UNITED STATES PATENT AND TRADEMARK OFFICE

Office Action Summary

10/065,758

DETAILED ACTION

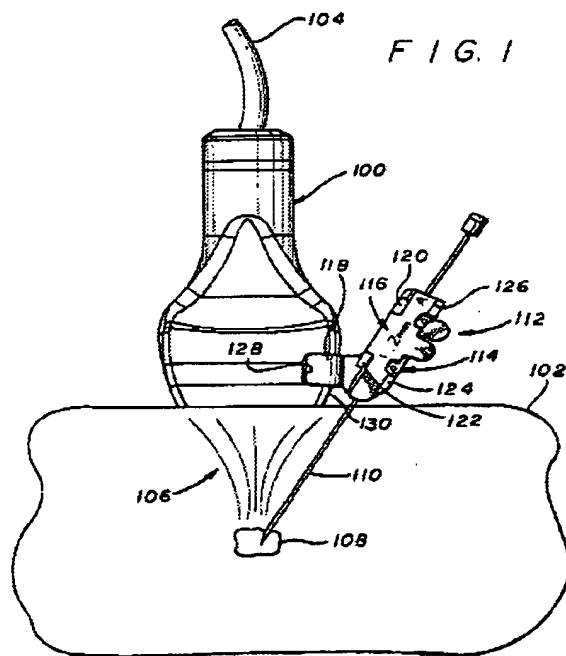
Regarding claim 1, Miller discloses wherein a medical imaging system comprises of:

- 1) a transceiver bracket being sized and shaped to secure with an imaging transceiver (118)
- 2) the transceiver/bracket covers the sterile sheath disposed over the imaging transceiver (column 5, lines 10-25)
- 3) a needle guide disposed over the transceiver/bracket (112)
- 4) a lock comprising a void in the transceiver bracket and a first pliable clamp leg allowing needle guide to be detached (Figure 1)

FIG. 2

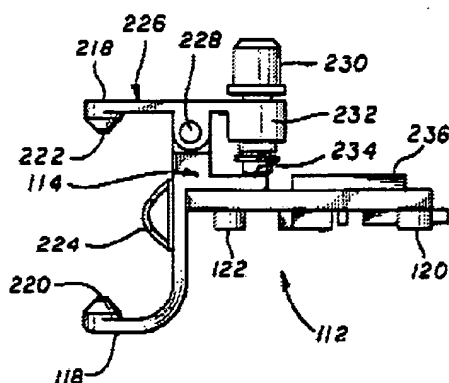
Regarding claim 2, Miller discloses wherein the first side clamp leg is coupled to a needle guide (Figure 2).

Regarding claims 3 and 4, Miller discloses wherein a second clamp leg is disposed on an opposing side with a leg protuberance (220) (Figure 2).

FIG. 9

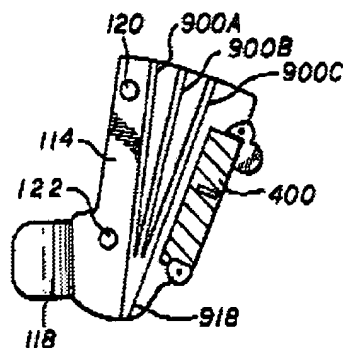
Regarding claim 5, Miller discloses wherein the needle guide is configured to receive needles at various locations and angles (Figure 9).

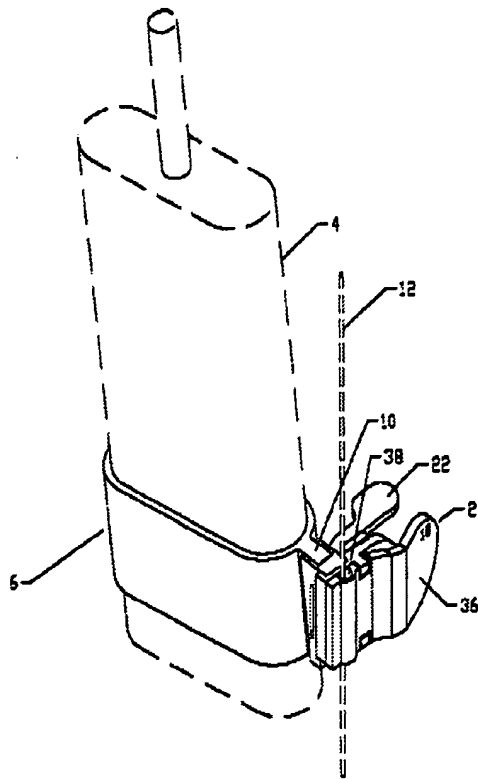
Regarding claim 6, Miller discloses wherein the needle guide an enlarged end, facilitating grasping of the needle guide (Figure 1).

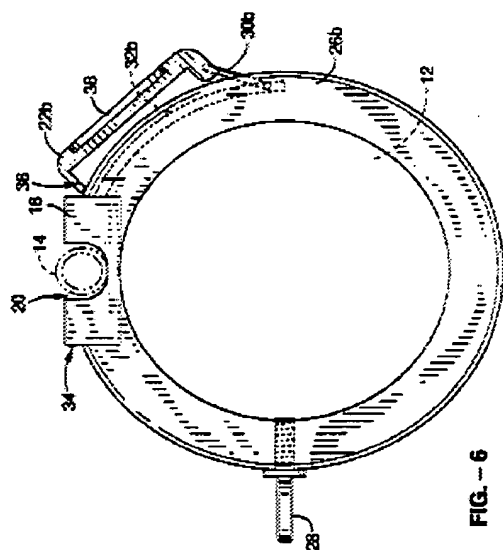
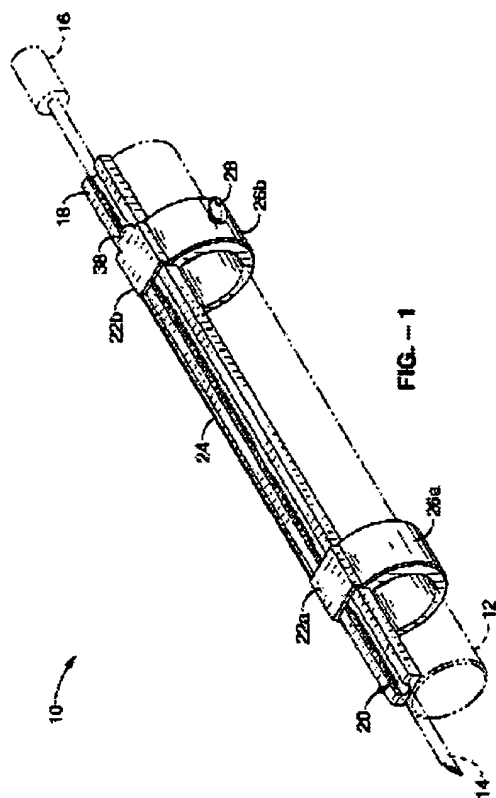
Regarding claims 7, 17, 19, and 21, McGahan discloses wherein an endocavity imaging system comprises of an endocavity imaging transceiver (abstract), a mounting bracket coupled to the imaging transceiver (26 a and b), a needle guide coupled with the mounting bracket so as to create a lock between the needle guide and mounting bracket (18). McGahan does not disclose wherein the lock is a single use lock incapable of affixing the needle guide to the mounting bracket.

Regarding claims 8 and 18, McGahan discloses wherein the lock comprises a plurality of protuberances (34) which mates with a void to lock (Figure 6).

Regarding claim 9, McGahan discloses wherein the structure is a void in the mounting bracket (Figure 6).

Regarding claim 10, McGahan discloses wherein the needle guide central cannula section is recessed in a mounting bracket needle guide-receiving slot (18) (Figure 1).

Regarding claim 11, McGahan discloses wherein the mounting bracket is a partial sleeve disposed about a reduced cross-section imaging transceiver (Figures 1 and 6).
